# Access Compliance Report

## Public Rights-of-Way

### (Pedestrian Signals)

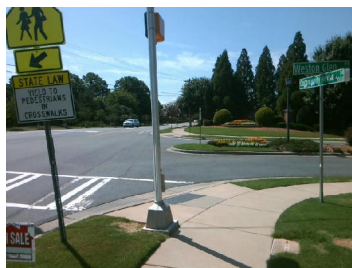
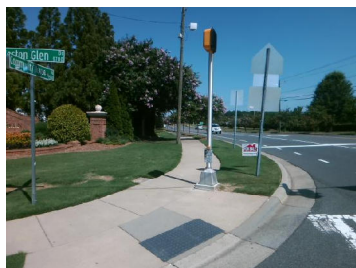
Possible Solutions: Provide Push Button Extension. Remove and Replace Clear Space.

PROW/ADA: R404.2, R406.2
